# JOINT REGIONAL PLANNING PANEL (Sydney East Region)

## SUPPLEMENTARY ASSESSMENT REPORT

JRPP No	<b>2016SYE015</b>
DA Number	<b>DA 487/2015</b>
Local Government Area	<b>North Sydney Council</b>
Proposed Development (As Amended)	<b>Demolition of existing residential flat building and construction of mixed use building consisting of 99 apartments, commercial space and 85 car-spaces (Amended proposal)</b>
Street Address	<b>229 &amp; 231 Miller Street, North Sydney</b>
Applicant	<b>Yaver Pty Ltd</b>
Owner	<b>Yaver Pty Ltd</b>
Number of Submissions	<b>Six (6) submissions (Original Proposal) Two (2) to subject amended proposal</b>
Regional Development Criteria (Schedule 4A of the Act)	<b>Capital Investment Value &gt; \$20 m</b>
List of All Relevant s79C(1)(a) Matters	<b>North Sydney LEP 2013 - Zoning – B4 Mixed Use North Sydney DCP 2013 S94 Contributions SEPP No. 55 – Remediation of Land SEPP No.65 – Design Quality of Residential Flat Development – Apartment Design Guide SEPP (Building Sustainability Index: BASIX) 2004 SREP (2005) – Sydney Harbour Catchment</b>

**Figure 13:** Isometric drawing extract DA53(D) showing the proposed relationship with No. 225 Miller Street at Levels 16 & 17.

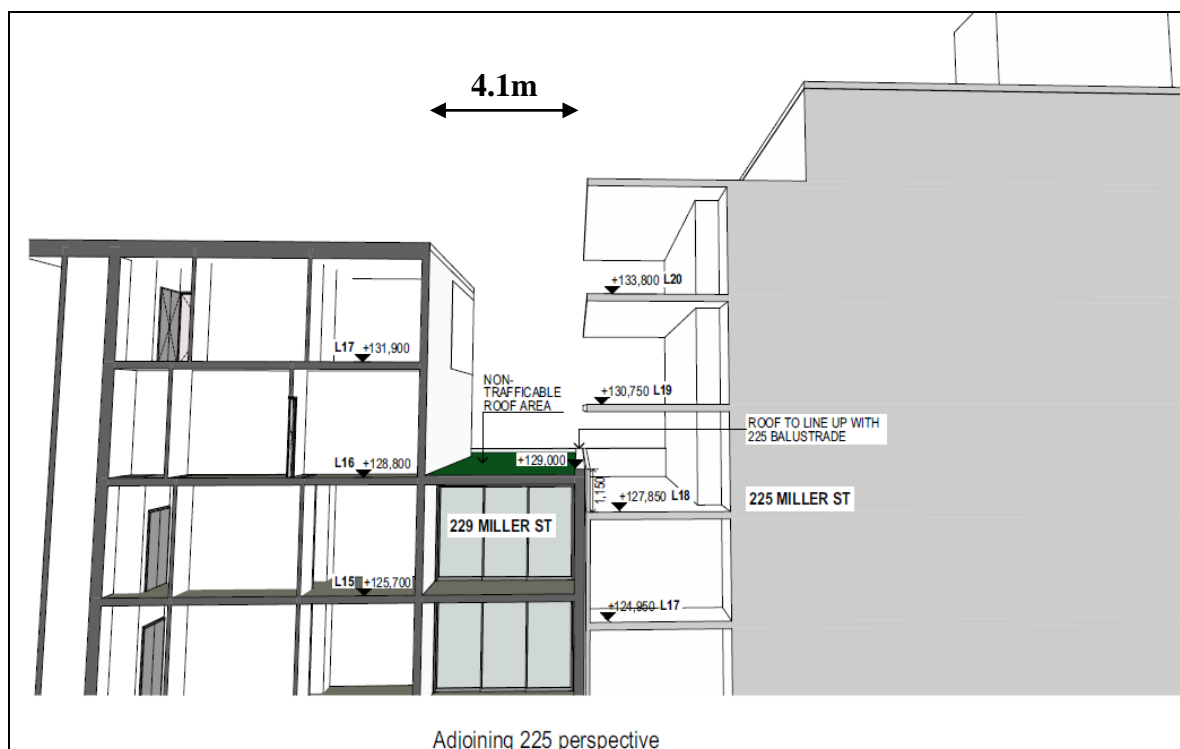
The modifications to the floor to floor heights within the development has translated to an altered non-trafficable roof top area at Level 16 immediately adjacent to the existing missed use building at 225 Miller Street. The resulting building interface has reduce the RL of the roof top area so as to reduce the impact at this interface.

Additionally detail has also been lodged regarding the interface of the non-trafficable green roof and the existing balconies of the adjacent existing building. The applicant has provided a detail drawing showing revised floor levels adjacent to the east facing balconies of No. 225 Miller Street as shown in below in figure 13:

It is generally acknowledged that the relationship between the subject proposal and the adjoining building at 225 Miller is poorly resolved. However the development remains compliant with height and massing requirements at this location. The eastern facing balconies of the adjoining development, will be impinged by the height and location of the two storey plant room and western elevation of the building at Level 16 & 17.

The building separation requirements for habitable to non-habitable spaces as required by the ADG's is however non compliant, with a minimum separation of 18 metres required. However in light of the compliant building height and the non-compliant setback of the adjoining balconies consideration should be given to a reduce set back.

Having regard for the proposed building layout at Levels 16 & 17, a minimum setback of 8 metres from the common boundary with No. 225 could reasonably be achieved by reduction in the plant room floor space and by deletion of bedrooms in Unit 1 at Levels 16 & 17. Such reduction would substantially improve outlook to the north-east of the top floor units in No. 225, being the approved location of living rooms whilst allowing a compliant height building on the subject site.

**Figure 14:** 9:30am Sun's eye view 21 June

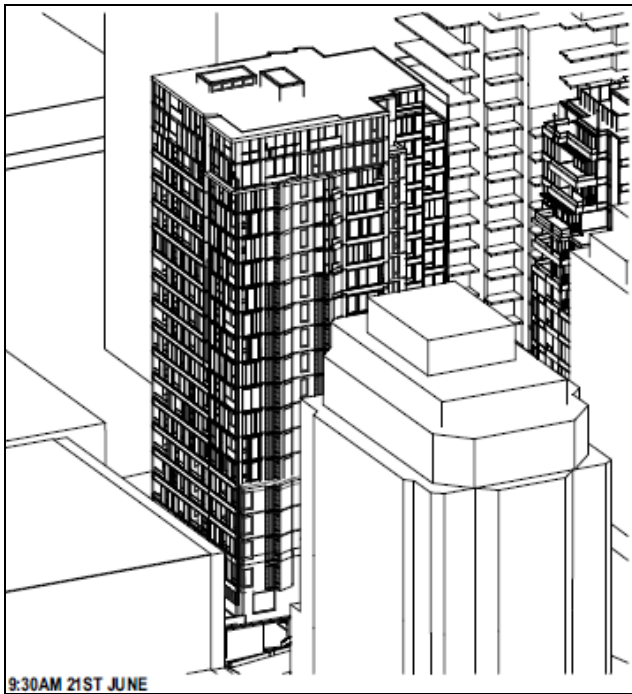
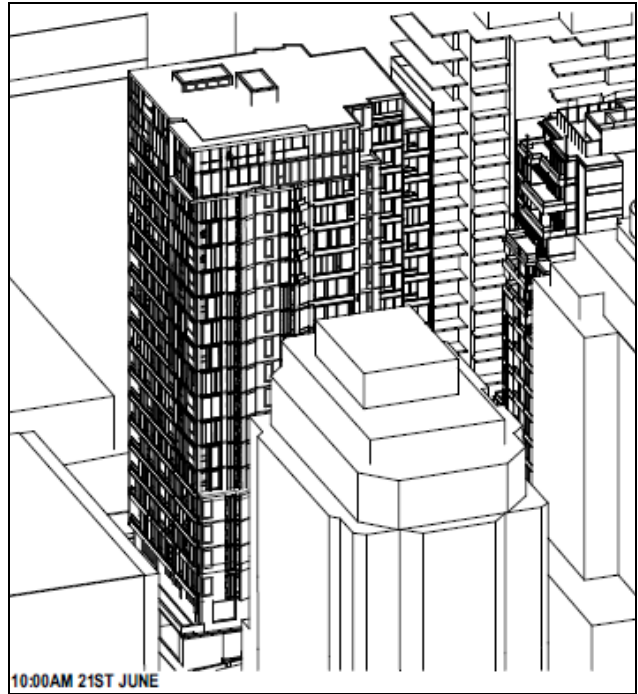
The development however relies disproportionately on winter gardens to compensate for a larger number of south-east facing dwellings with narrow openings to the east façade which do not achieve solar access to internal areas. The orientation of the site at 9 degrees south of east results in the majority of these units failing to achieve adequate the minimum 2 hours minimum direct sunlight to internal living areas during mid-winter in accordance with the ADGs.

This is best illustrated in the applicant's view from the sun diagrams which show the eastern face of the building receiving increasingly oblique direct sunlight access from 9:30am as shown in Figure 14 & 15 below:

The resulting solar performance of these units therefore remains substantially below the performance required by the ADGs and as such further amendment is recommended.
